INDIAN POINT STATION UNIT NO. 3

AMENDMENT TO FACILITY OPERATING LICENSE

Amendment No. 38
License No. DPR-64

ATTACHMENT TO LICENSE AMENDMENT NO. 38

FIGURE 6.2-2
 POWER AUTHORITY OF THE STATE OF NEW YORK
 INDIAN POINT NUCLEAR POWER PLANT
 PLANT STAFF ORGANIZATION

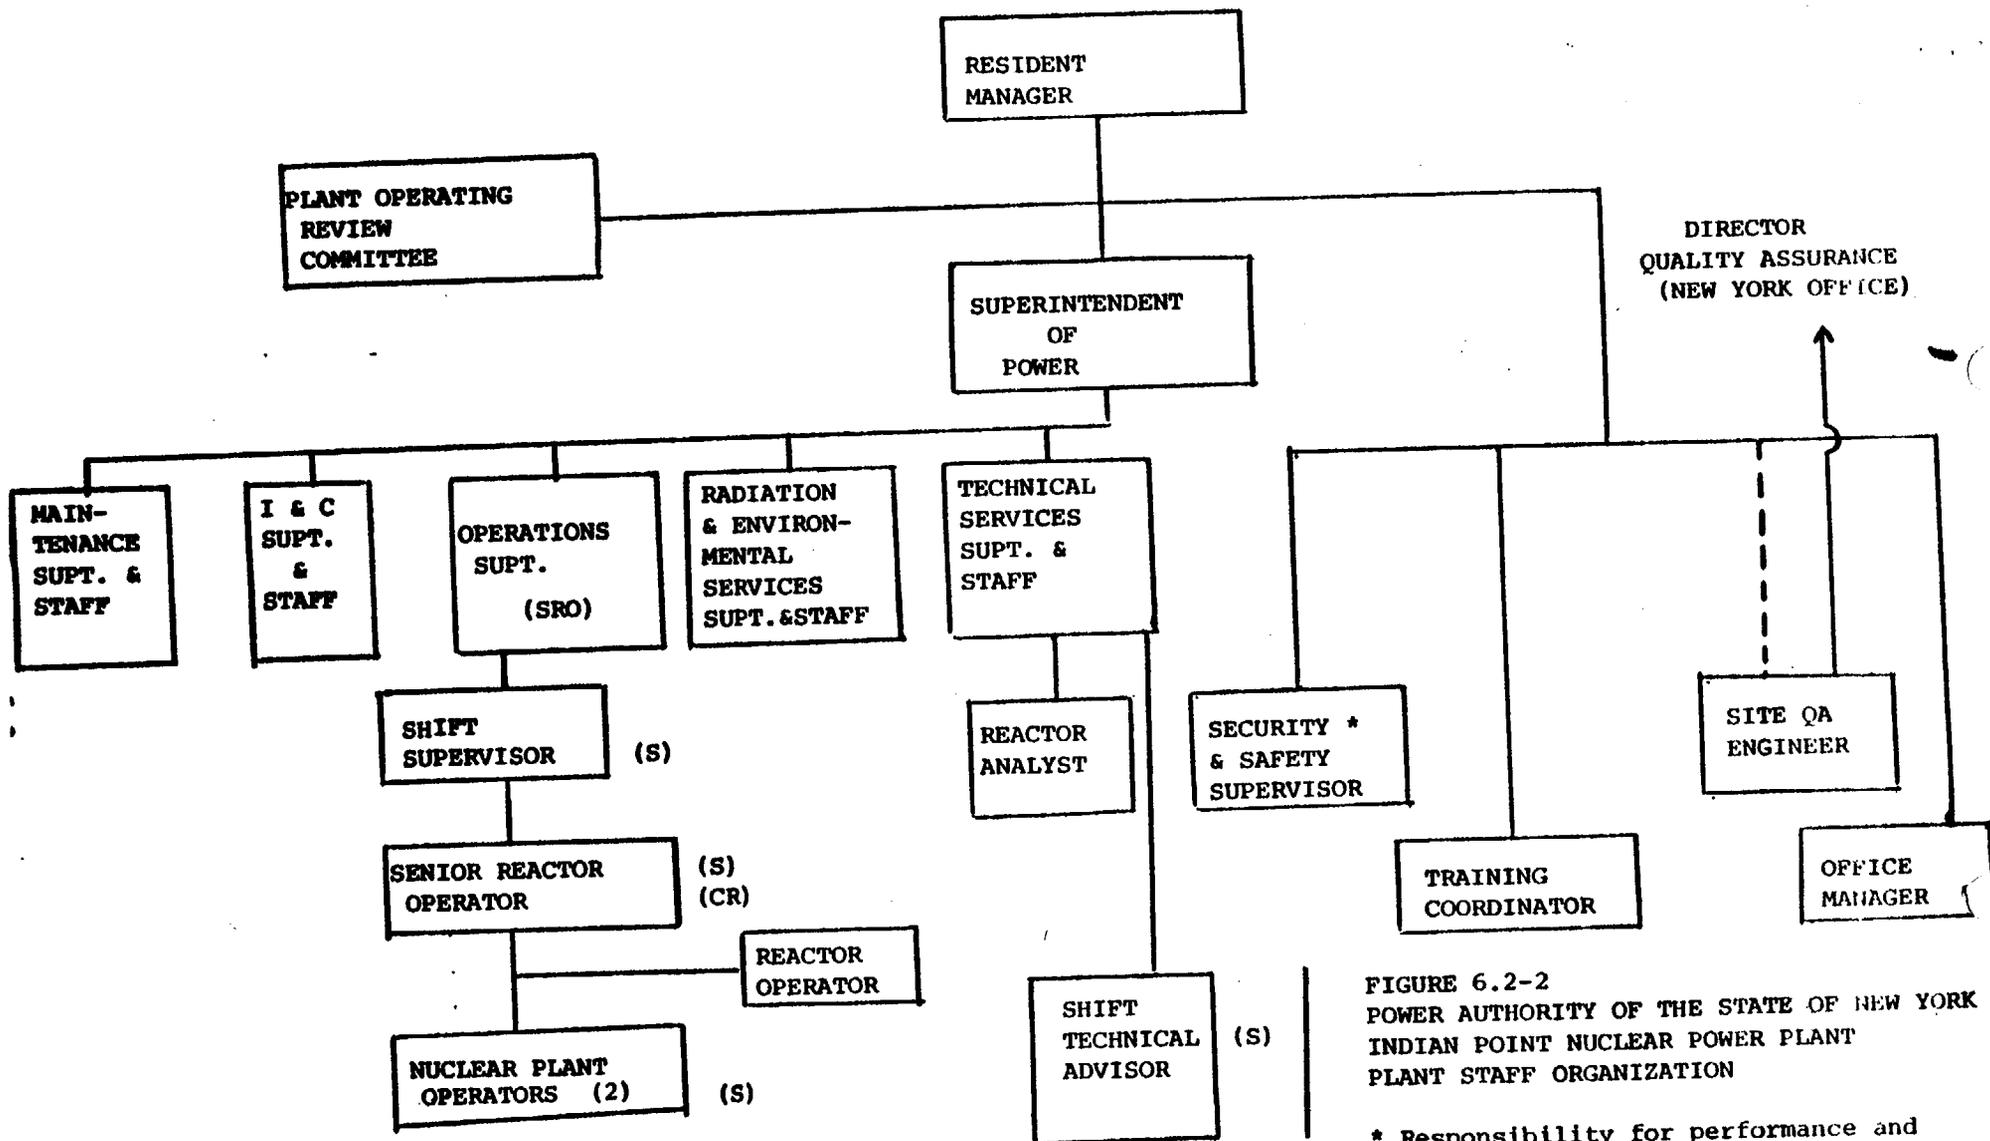
6.2.2 The Plant organization shall be as shown on Figure 6.2-2 and:

- a. Each on duty shift shall be composed of at least the minimum shift crew composition shown in Table 6.2-1.
- b. At least one Licensed Operator shall be in the control room when fuel is in the reactor.

- g. One shift Technical Advisor shall be on site at all times during which the reactor is above the cold shutdown condition.

2.2.1.b Shift Technical Advisor (STA)

Our request indicated that the TSs related to minimum shift manning should be revised to reflect the augmentation of an STA. The licensee's application would add one STA to each shift, except for cold shutdowns and refuelings, to perform the function of accident assessment. This clarifies the requirement in the February 11, 1980 Confirmatory Order that the STA be "on shift."
